Anomaly F30005

Draft DIGITAL GEOPHYSICAL MAPPING QUALITY ASSURANCE FORM (Anomaly Resolution)

U.S. Army Engineering & Support Center, Huntsville
SWMU 2, Interim Removal Action, Deseret Chemical Depot
UXB-KEMRON Remediation Services, LLC
Lot ID: Grids A2, A3, B1, B3 and B4

Figure 1

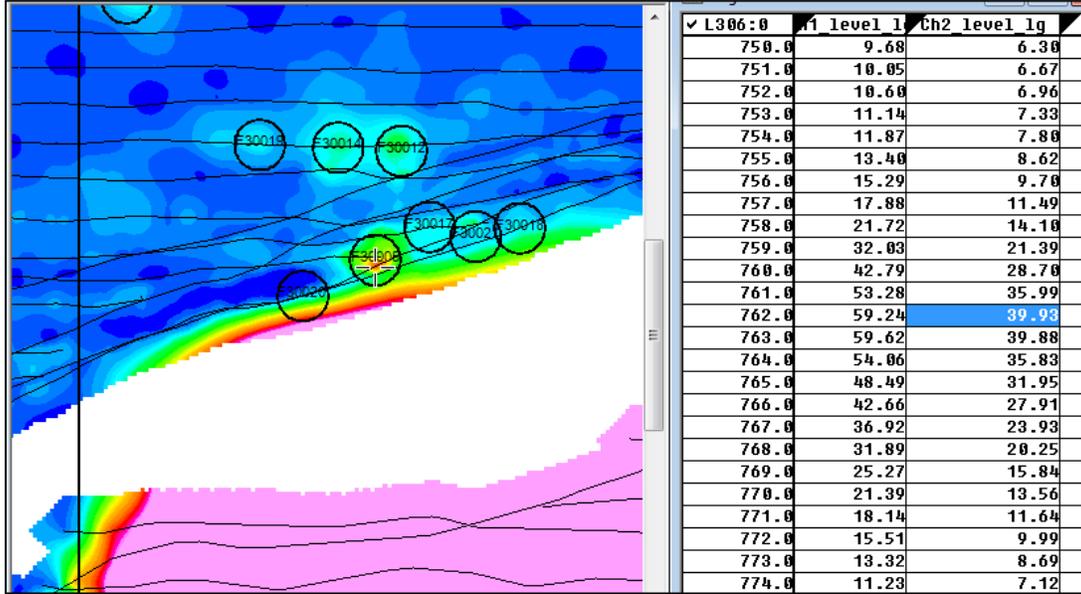
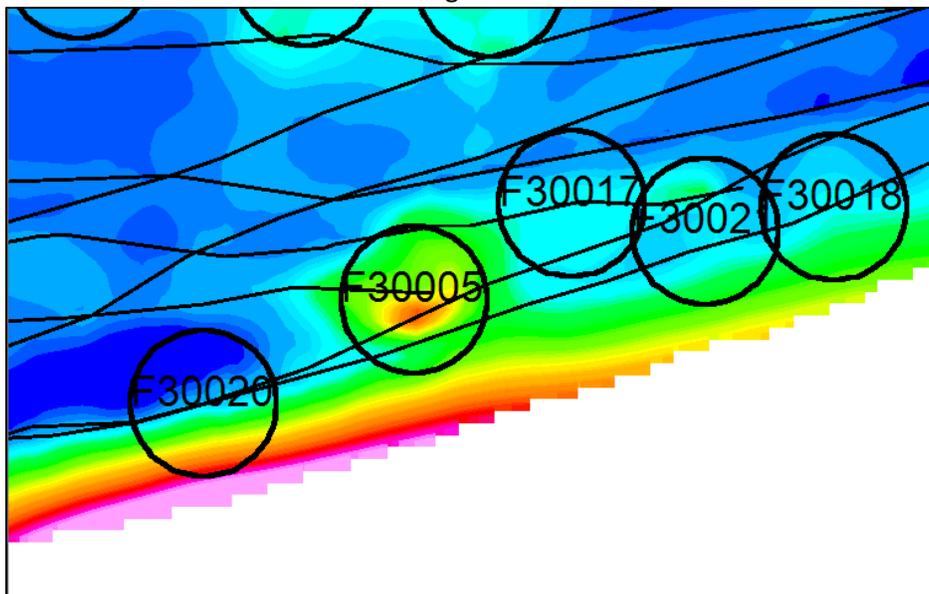
Figure 1 below shows the location of Target F30005. The Burial Pit is immediately located to the south of this anomaly.

The area in the vicinity of Target F30005 was used for staging, processing and packaging of material from the main burial pit that is located to the south of Target F30005 (See Figure 1 above). This staging, processing and packaging area was traversed 100s of times during the ingress and egress of an all-terrain forklift during the retrieval and extraction of each of the E46 bombs. Additionally, this area was traversed by other heavy equipment during the removal of overburden and soil intermingled with DMM. Figure 3 below is representative of the soil and debris that was removed during the excavation of the main Burial Pit. Note that the image below shows the close proximity of single point anomalies to the excavation debris that was collected.
